Service Bulletin

Title: SB EC145-022216; Airbus EC145 Heater Hose Chaffing Prevention Measures

Date: 25 February, 2016

Applicability: Airbus Helicopter model EC145 equipped with the Air Comm Corporation air conditioner system, all kits prior to Jan. 2014.

1. Refer to section view G-G shown on the overall aircraft view below and in detail on the following page.

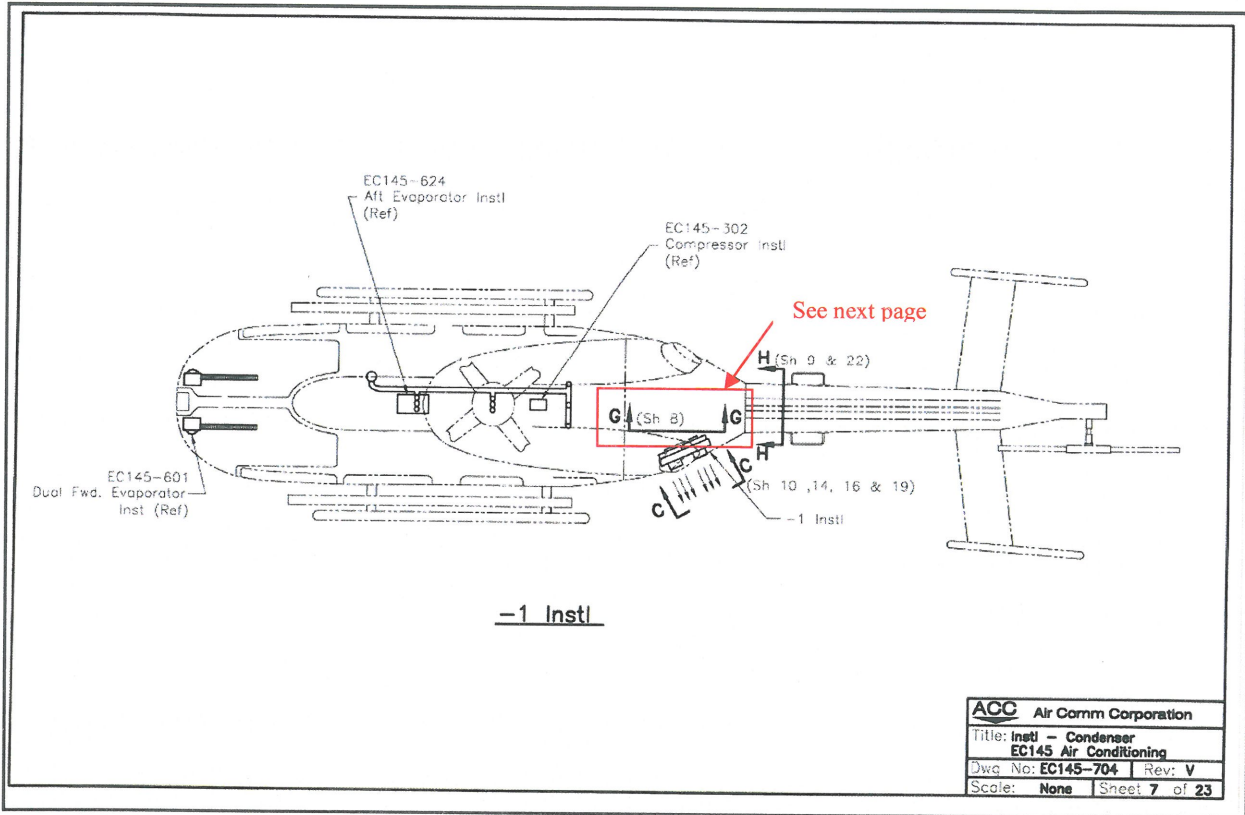
2. Note the cross hatched zones shown in view G-G on page 3. If the aircraft is equipped with thermal sleeving on the two heater tubes in this region then this Service Bulletin does not apply. The sleeving will provide the necessary anti-chaffing function. However, verify the .6in. clearance between sleeving and structure per the note in view G-G. Adjust the clamping of the tubes if necessary to achieve this clearance.

3. If the aircraft heater tubes are not supplied with the thermal sleeving in the noted region, inspect the heater lines to ensure there is no damage to the heater lines if chaffing has occurred. Contact ACC for the materials and install the ES06005-6 spiral wrap material onto the hoses as noted by the cross hatched region in view G-G below and flag note 11 below. Also, adhere the ES06004-3 tape to the airframe in the appropriate region that could be contacted by the tubing per flag note 11 below.

If factory hose covers are not previously installed, locally wrap the stainless steel covered heater hoses with ES06005-6 Spiral Wrap approx as shown, as required. Apply ES06004-3 Anti-Friction Tape to the longitudinal rib in the vicinity of the heater hoses, as required, to prevent chaffing of the heater hoses against the rib on the aircraft. (Sh 8)

△11 Longitudinal Rib
